Access Compliance Report Public Rights-of-Way (Pedestrian Signals)

Main Street: **BEACH BLVD** Cross Street: **BOLSA AVE** Location: **NE**

ADA ID: **SGRK210929151905** Signal Type: **One Push Button-Non APS** Overall Compliance: **No** Severity Scores: **BTN 1: 25** **BTN 2: N/A** **No BTN: N/A**

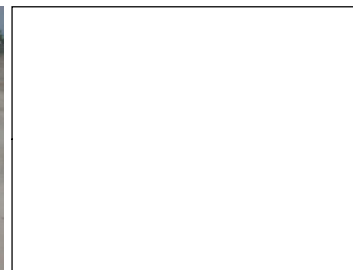
OC Std/PROW: R404.2

Possible Solutions: Remove and Replace Clear Space.
